PROJECT/TITLE  
**BUDGET CAR RENTAL**  
305 AMERICAN BLVD. WEST  
BLOOMINGTON, MINNESOTA

SHEET TITLE  
**EXISTING  
CONDITIONS &  
DEMO PLAN**

CASE FILE #PL201700125

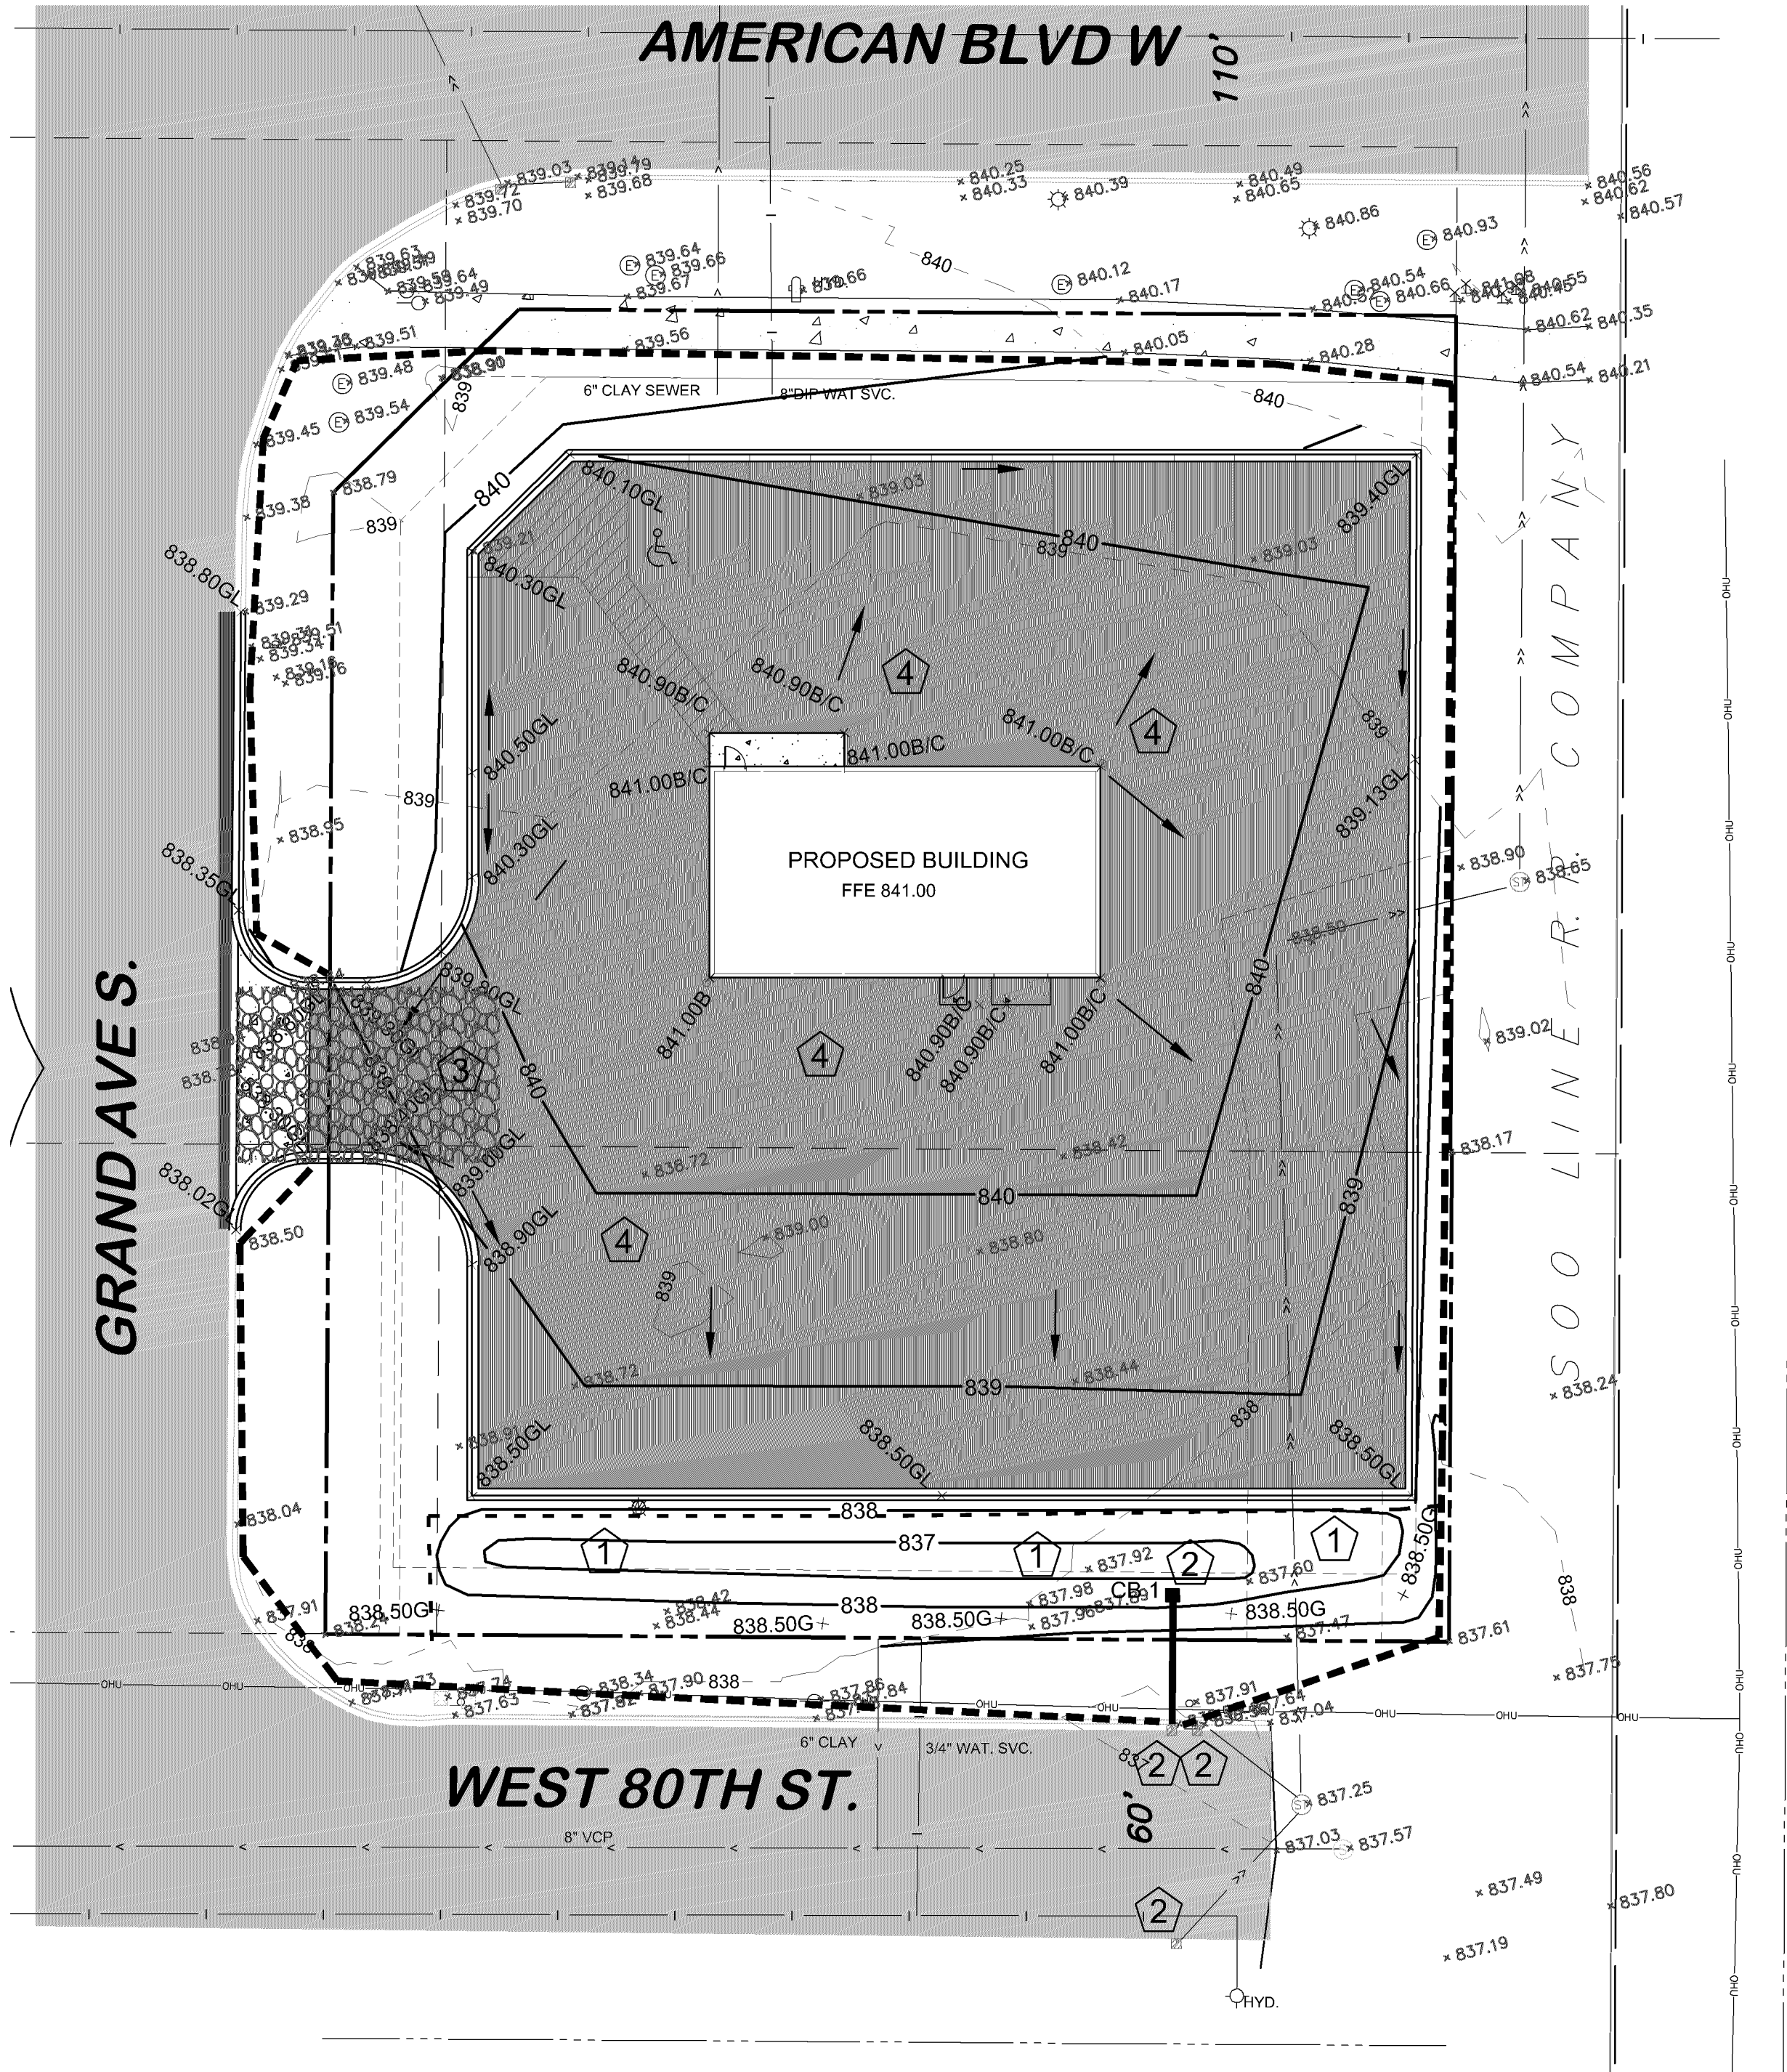
May need additional erosion protection at east and west curblines extended

No steel allowed within City ROW. Use Bloomington Non-Residential Driveway Detail.

SHEET NO.  
C3

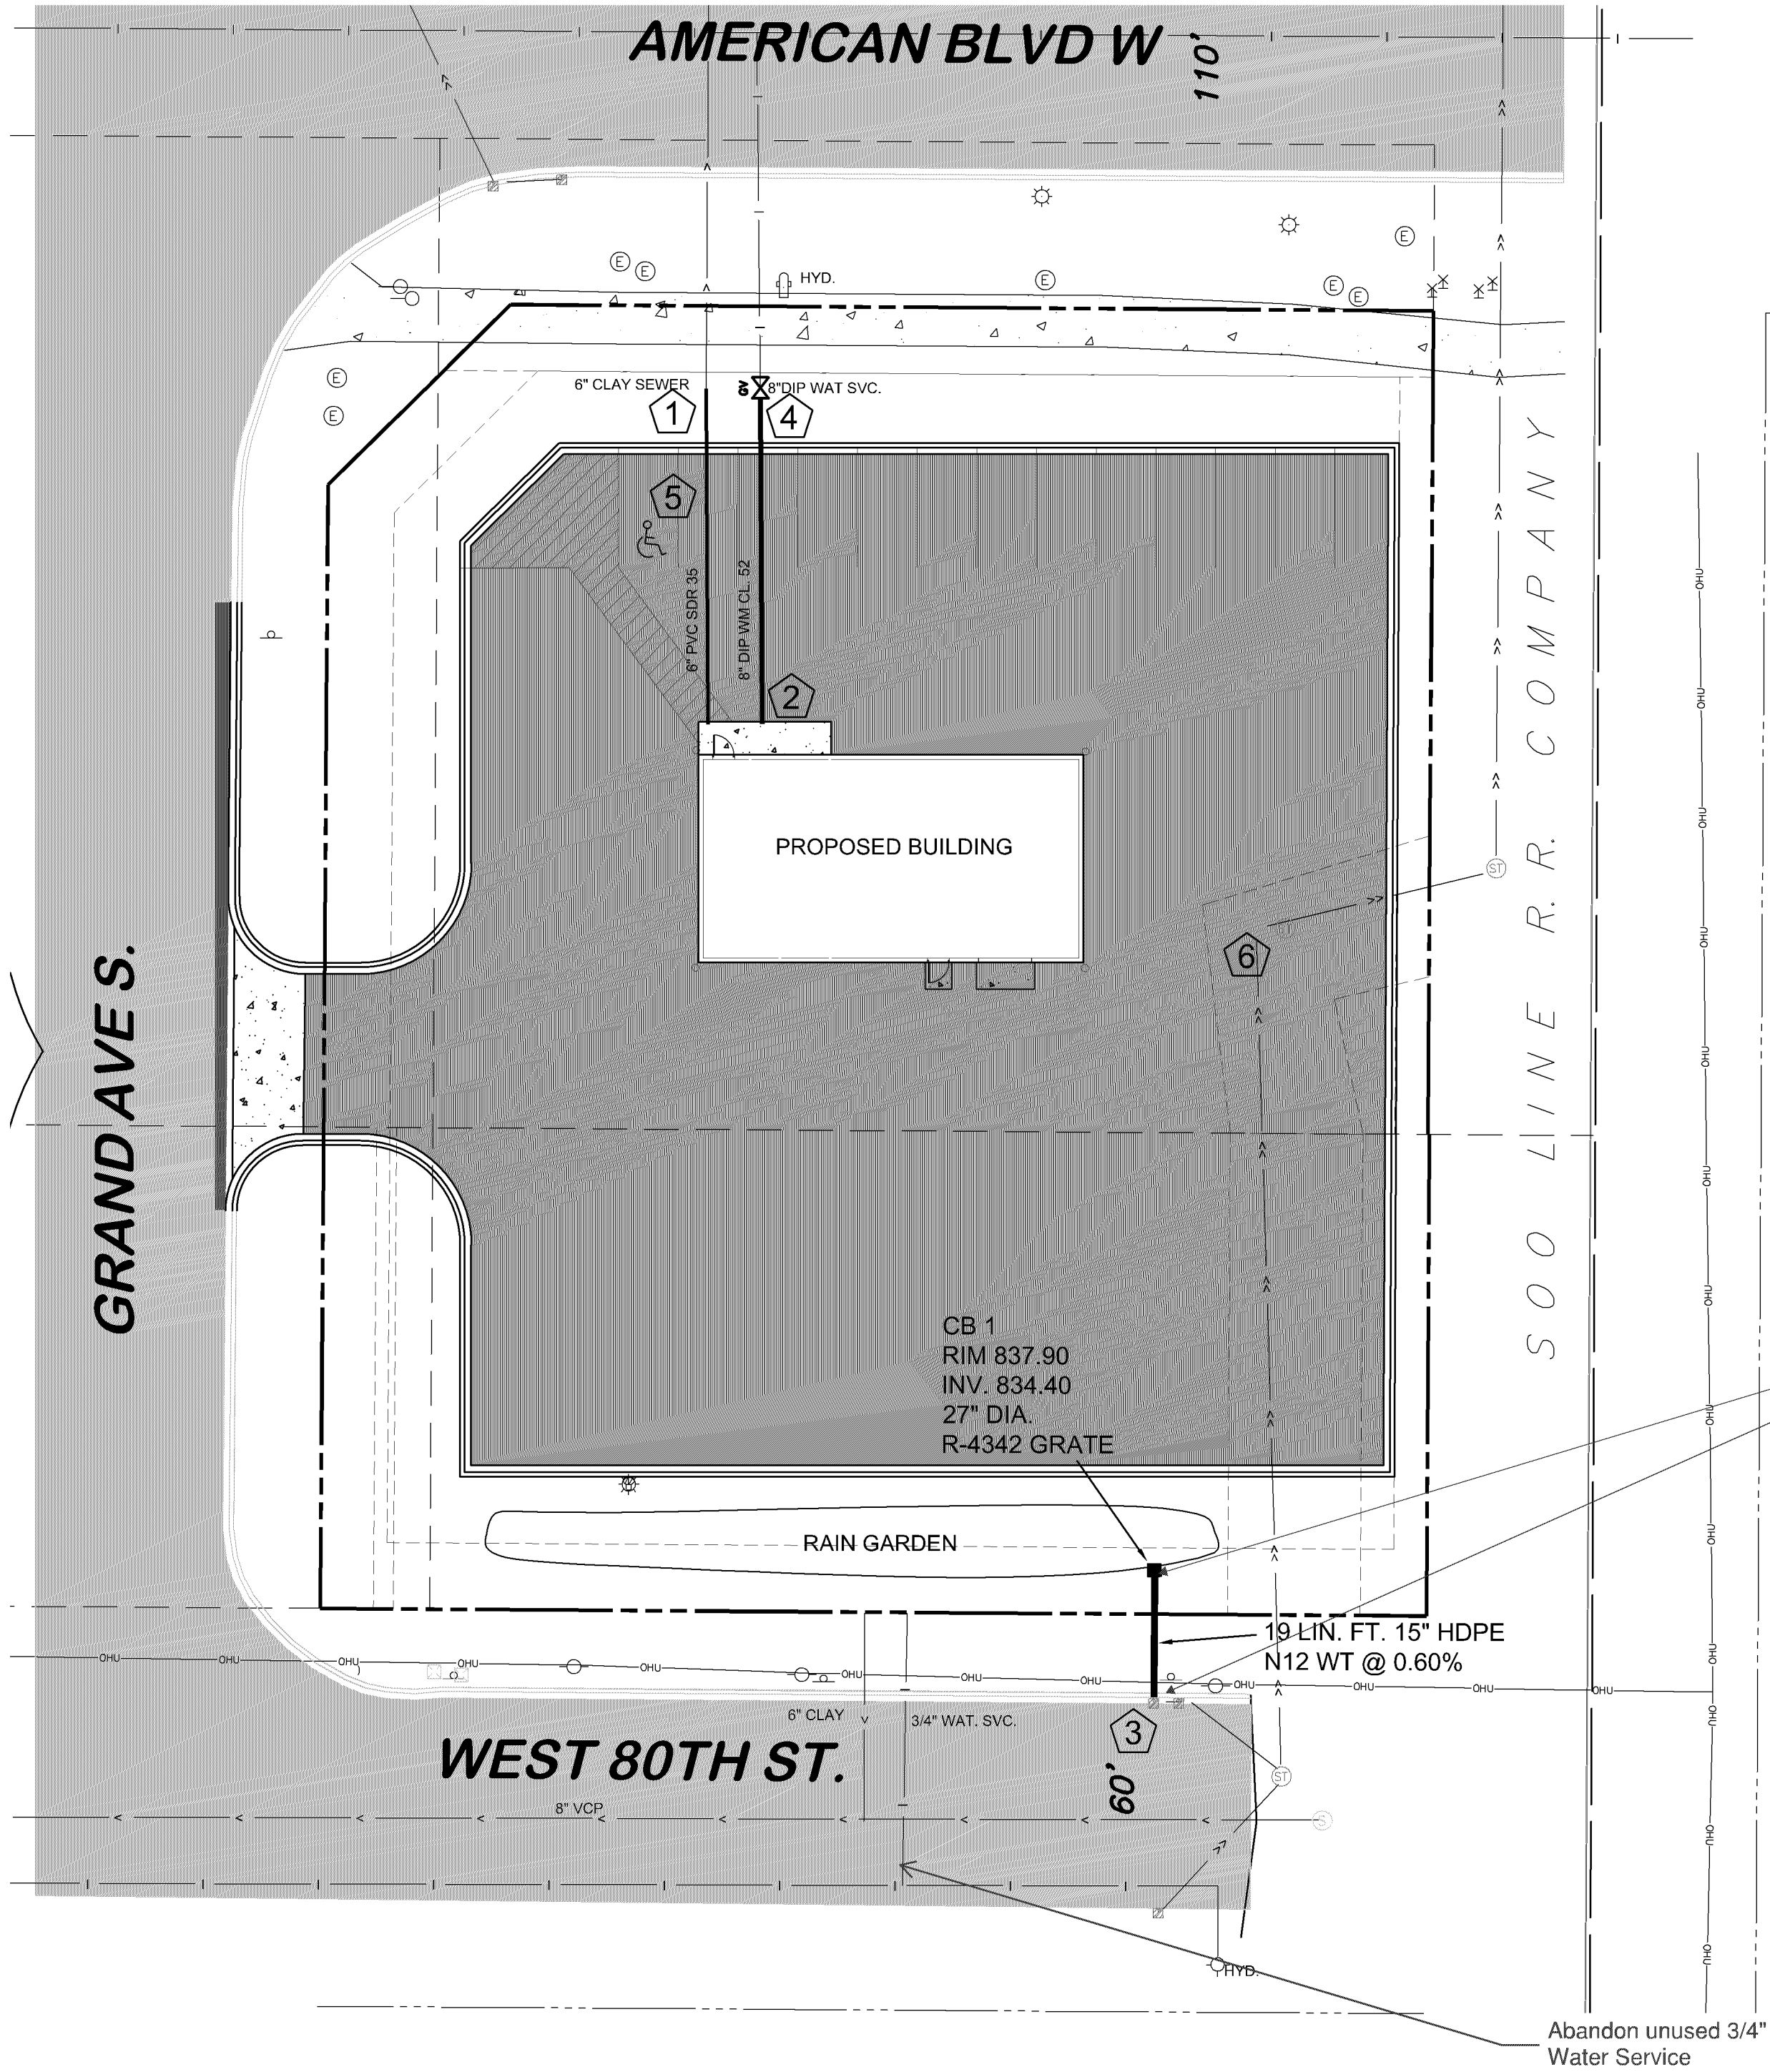
- KEYED NOTES:**
- CONNECT TO EXISTING SANITARY SERVICE WITH FERNCO ADAPTOR FOR CLAY TO PVC SDR 35. Lines must be tested into the building See Review Comments
  - END BOTH WATER SERVICE AND SANITARY SERVICE 5 FEET FROM BUILDING. TO BE CONNECTED BY BUILDING PLUMBER
  - CONNECT TO EXISTING STORM SEWER AND SEAL WITH CONCRETE.
  - CONNECT TO EXISTING WM STUB WITH 8" DIP WM, EXTEND TO BUILDING.
  - INSTALL 6" PVC SDR 35 AT 2.50% MINIMUM GRADE Use SDR 26 or Sch 40
  - ADJUST EXISTING STORM MH LID TO MATCH TO PROPOSED PAVEMENT

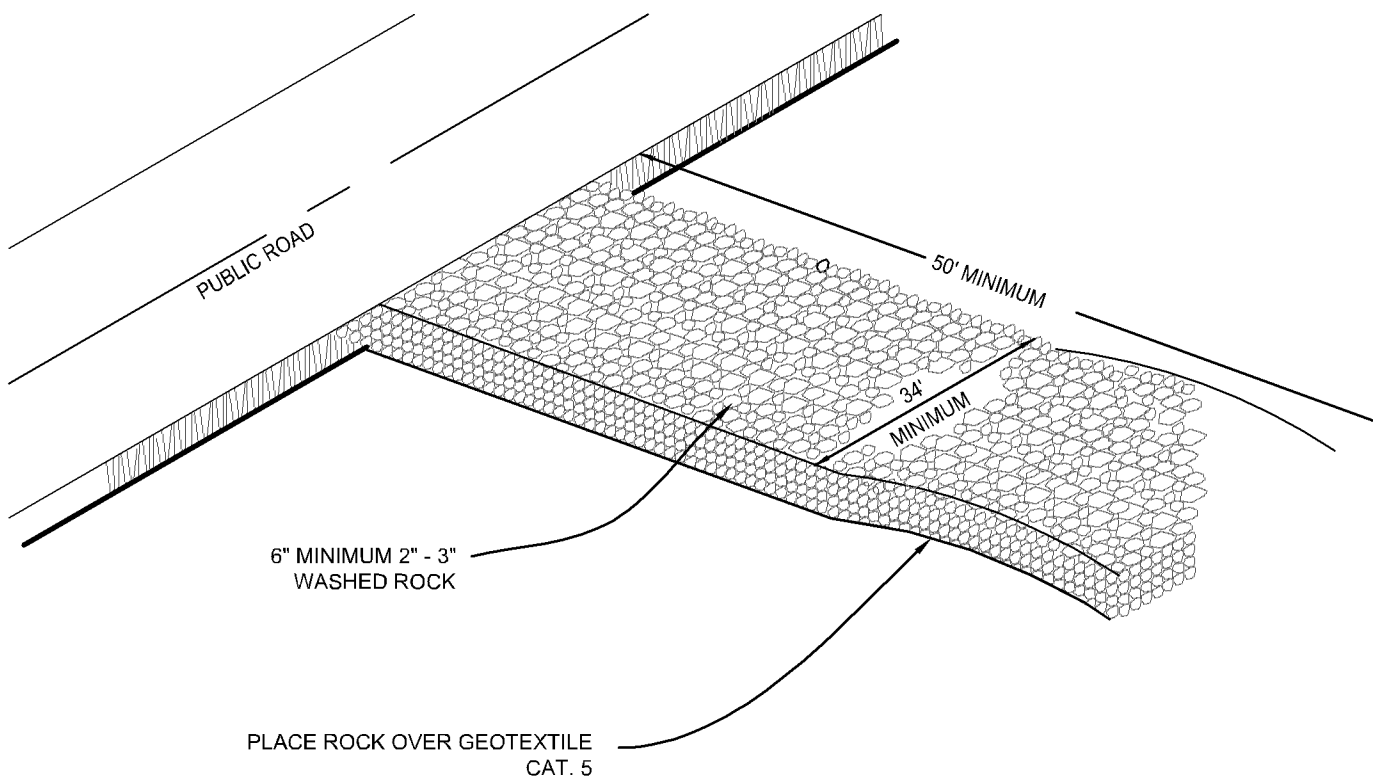
Replace with City of  
Bloomington Non-  
Residential Driveway  
Detail.
